components diagram

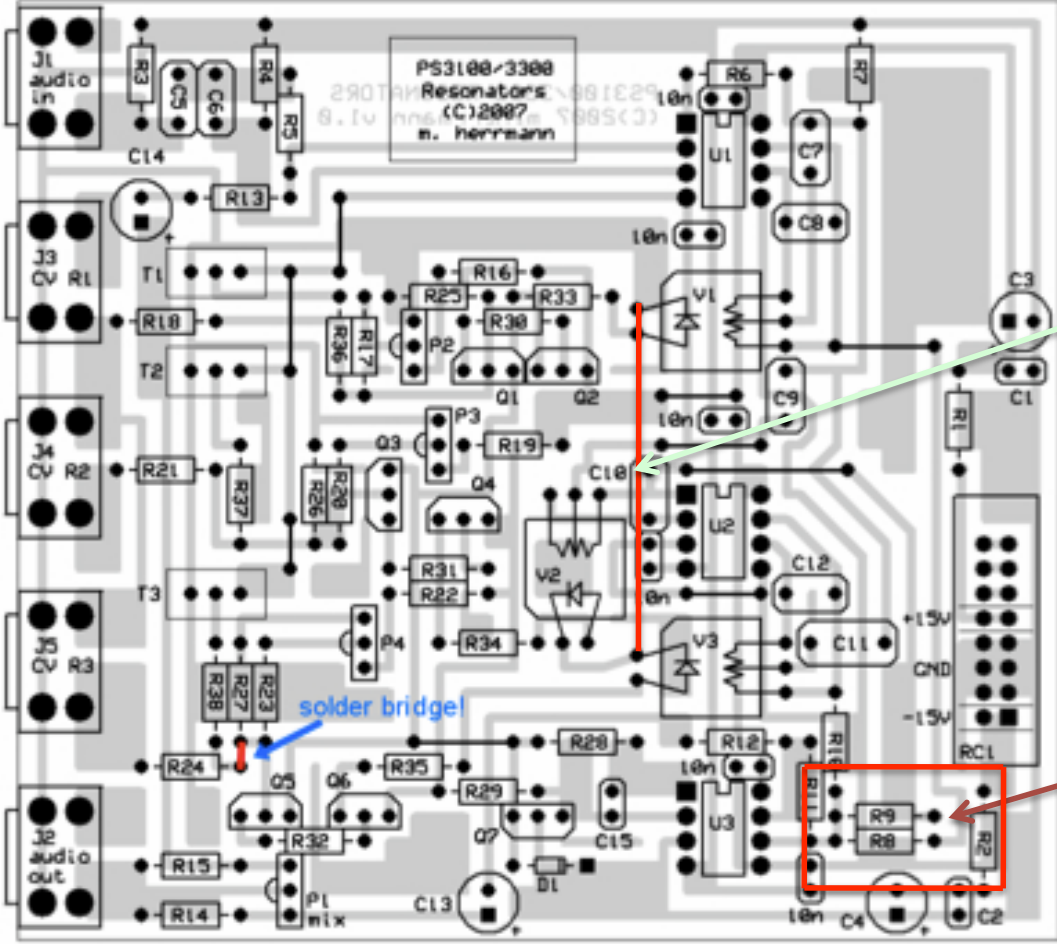
Solder a wire  
Between the  
cathodes of  
V3 and V1  
(cathodes  
from V2,V3  
need  
To be  
connected to  
ground)

R8,R9=10K  
Instead of  
270K
